Massachusetts Institute of Technology
Instrumentation Laboratory
Cambridge, Massachusetts

Apollo Project Memo # 1984

TO: Distribution
FROM: George W. Cherry
DATE: September 19, 1968
SUBJECT: Highlights of the 24th SCB Meeting Held at MSC
on 17 September 1968

Fig. 1 Suggested Implementation for PCR 244.

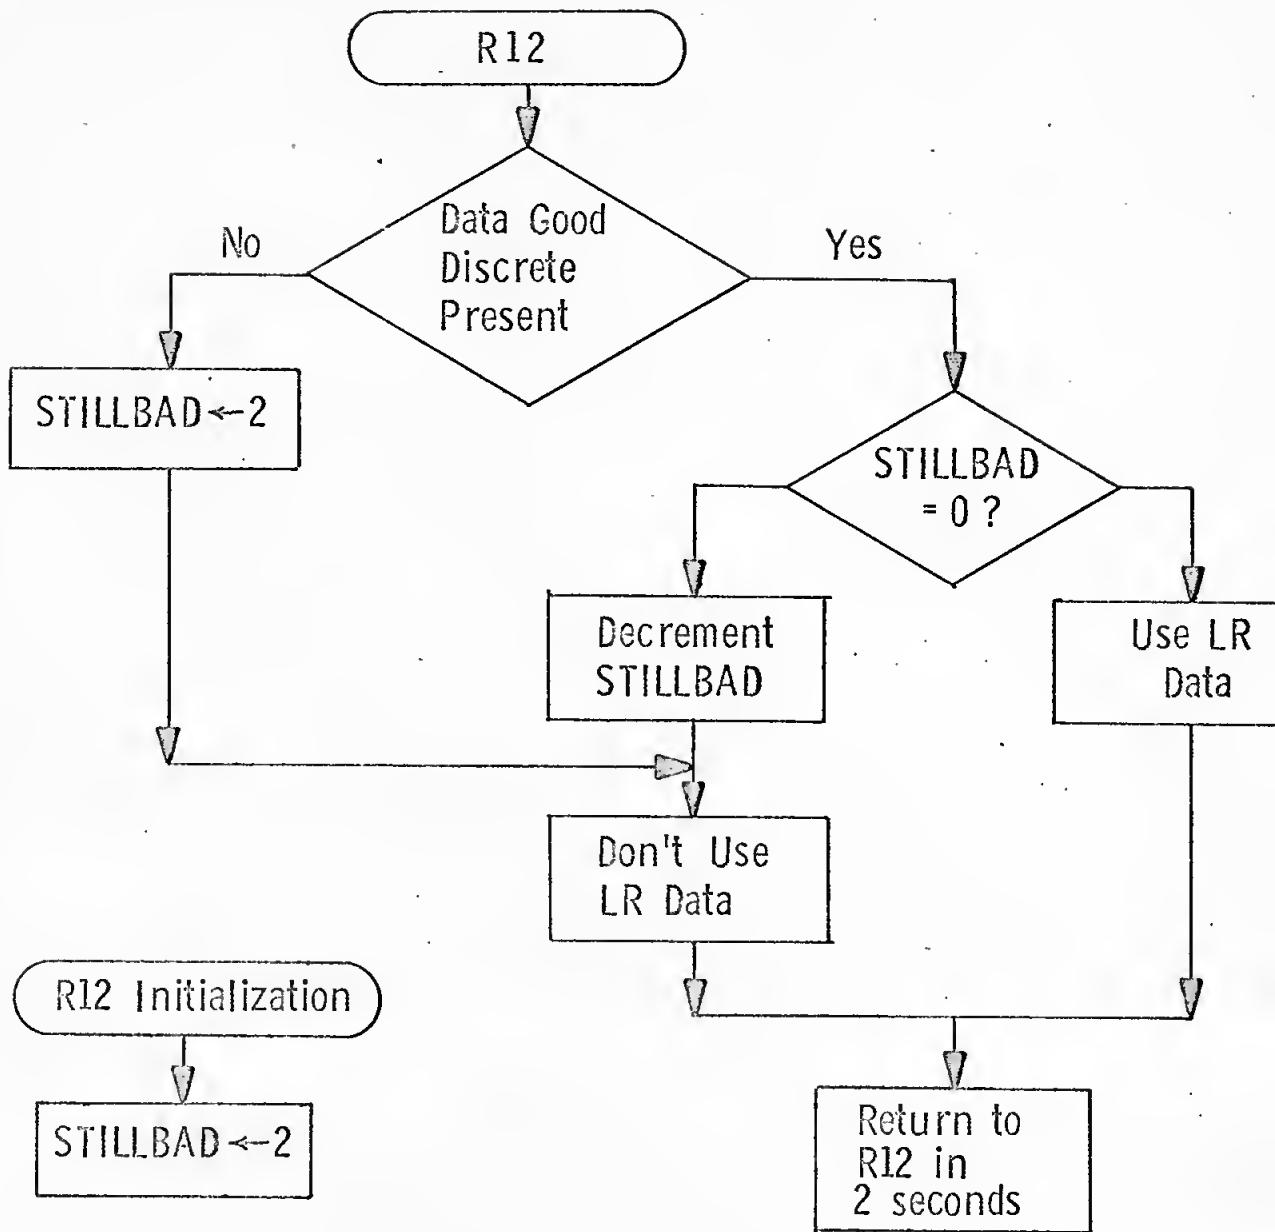
PCR 244 Delay use of LR Data for Four (4) Seconds after Detection of altitude and velocity Data Good Discrettes.

Now is the time for all good programmers to come to the aid of their country. The landing radar sends the "data good" signal before the data is good. Fixing this in the hardware costs like millions and like months. I suggest the implementation in figure 1.

Note: Two Monitors and two "STILLBAD's" are required, one for velocity and one for range.

Programming Action: Jim Kernan, Bob Covelli.

Fig. 2 New Antenna Repositioning logic.

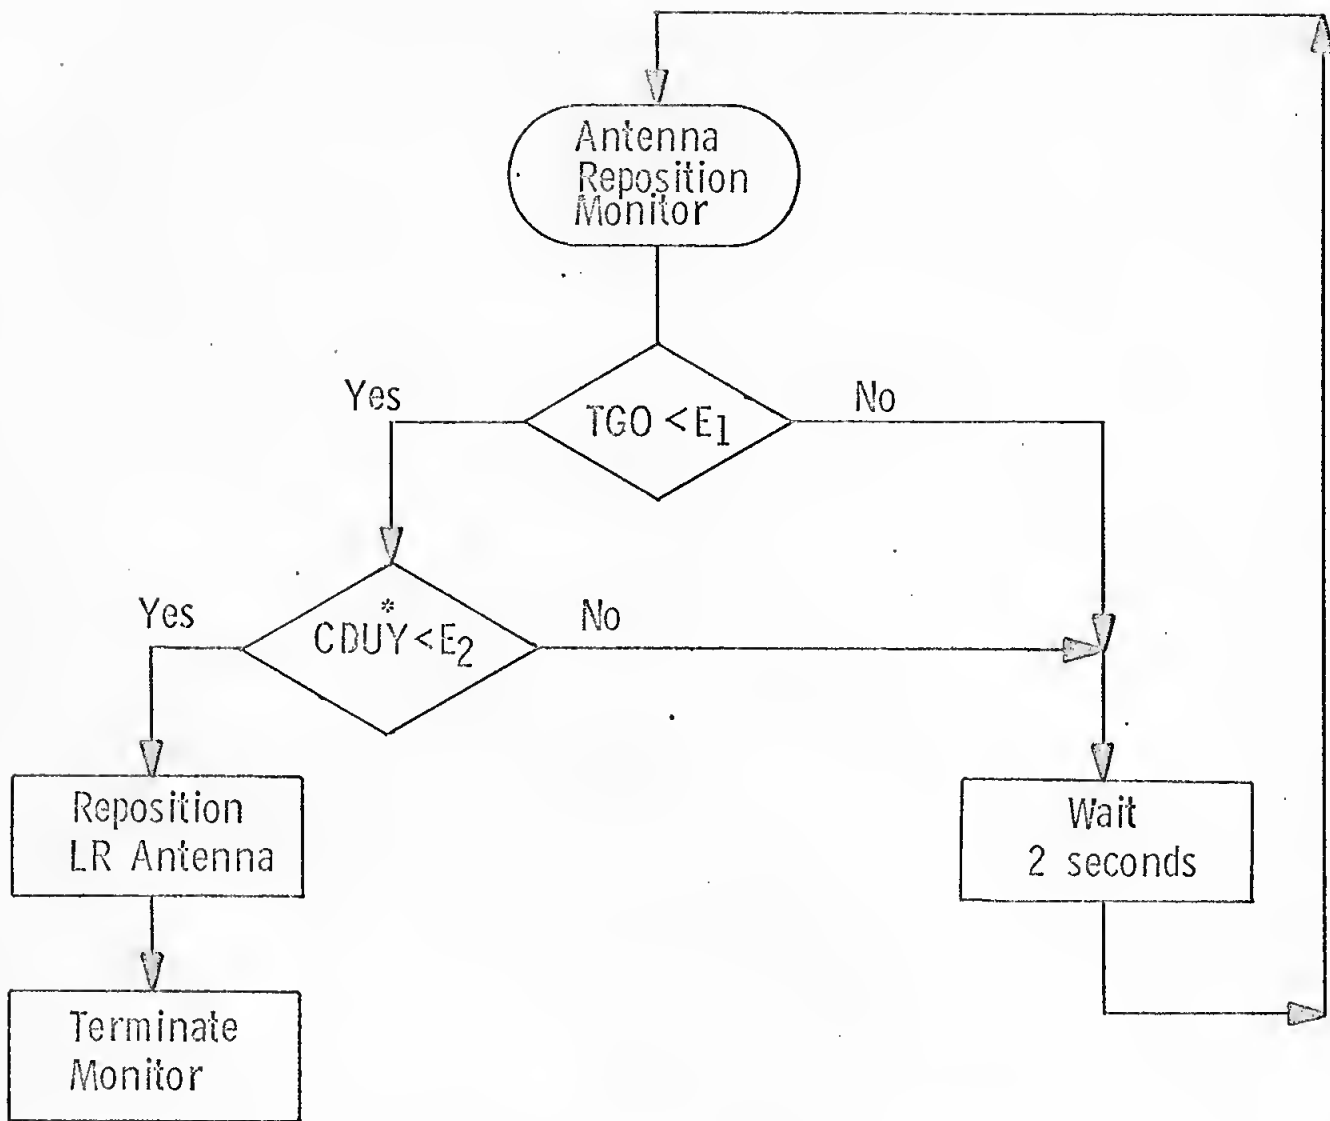
7. Re-position the LR antenna in accordance with the logic in Figure 2 of this appendix. This logic permits complete flexibility with respect to the criterion on which the antenna is re-positioned. If $E_1 = \text{POXMAX}$ then CDUY controls antenna re-positioning. If $E_2 = \text{POSMAX}$ then TGO controls antenna re-positioning. For 2 phase trajectories for example, $E_2 = \text{POSMAX}$ and $E_1 = 2$ seconds. For 1 phase trajectories E_1 could be set to a value which prevented very early re-positioning even if the CDUY E_2 criteria was satisfied.

* Computed pitch angle or angle between Radar antenna axis and the local vertical could be used instead of this check.

Coding - Bob Covelli

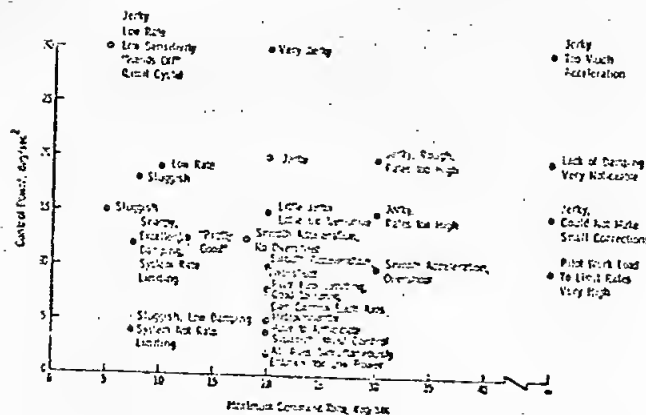
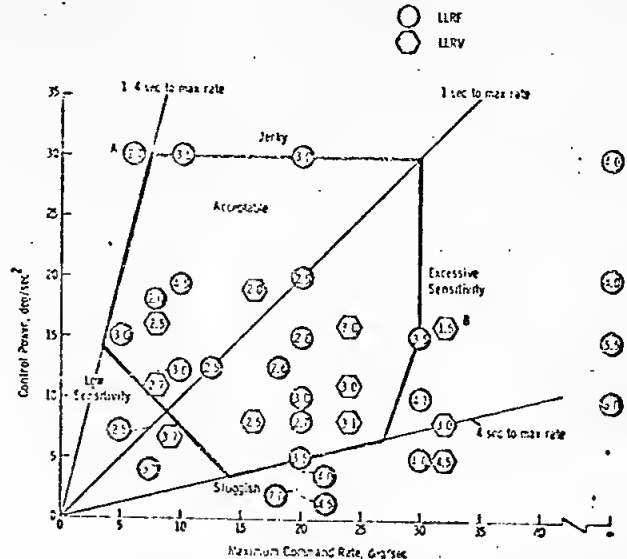
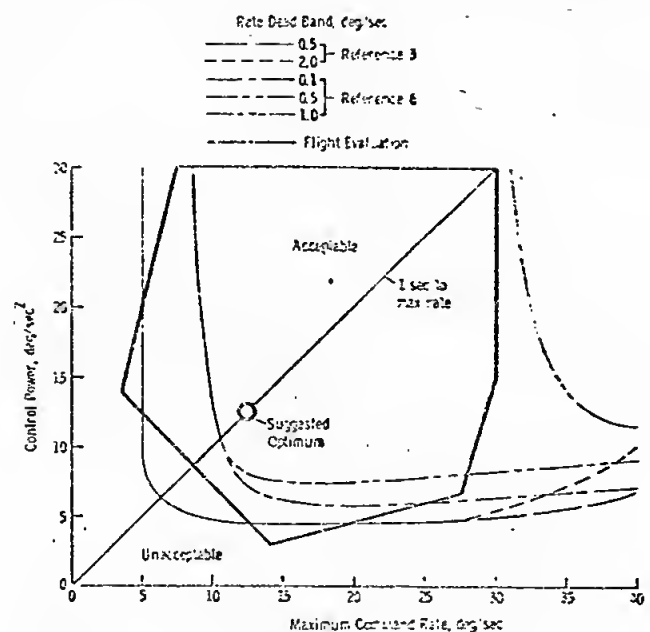
The results of flight evaluations with the Lunar Landing Research Vehicle (LLRV) and at the Lunar Landing Research Facility (LLRF), summarized in Reference 1, indicate that normal scaling of $14^{\circ}/\text{sec}$ produces better handling qualities at the lunar landing control power of about $10-12^{\circ}/\text{sec}^2$. As shown in the accompanying figures from Reference 1, this combination lies further within the "Acceptable Contour" and provides greater contingency control in the event reaction jet or trim gimbal failure.

Figure 22.— Comparison of LLRV ionap simulation attitude-rocket propellant consumption from flight-test data with fixed-base simulator results. $\dot{\theta} = 10 \text{ deg/sec}^2$ (0.18 rad/sec²); $\dot{\psi} = 11 \text{ deg/sec}^2$ (0.21 rad/sec²).

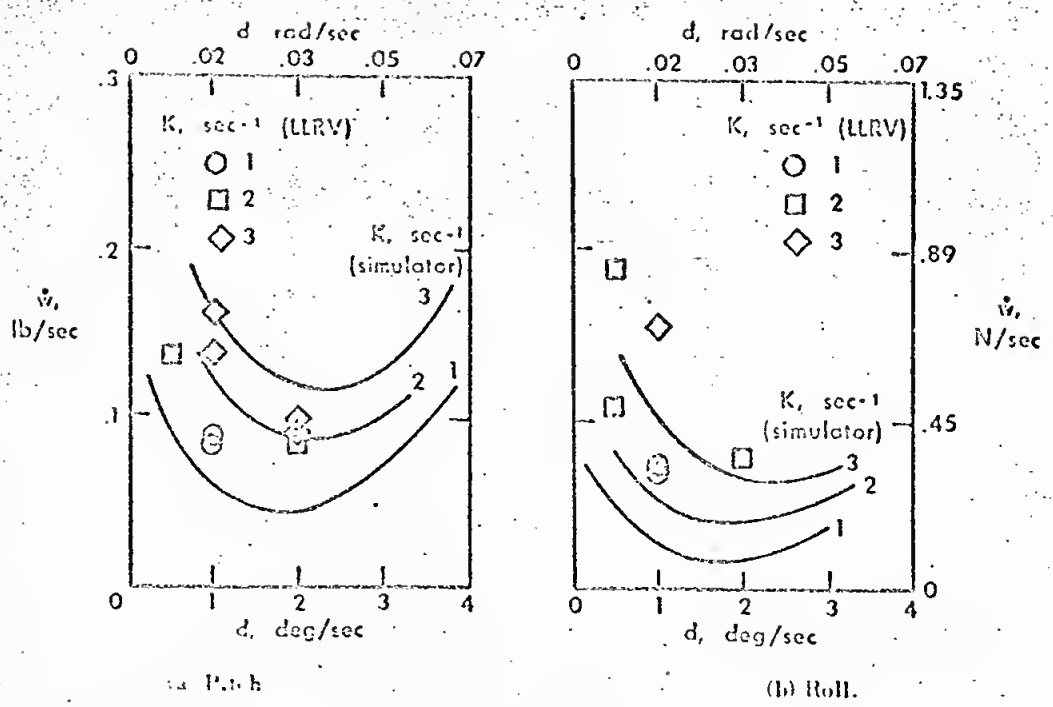
In Reference 2, attitude rocket propellant consumption of the LLRV is given as a function of stick scaling and rate deadband. In the figure from Reference 2, it can be seen that reduced stick scaling results in reduced propellant consumption. In view of current concern over control jet impingement, reduced stick scaling is again suggested by these data.
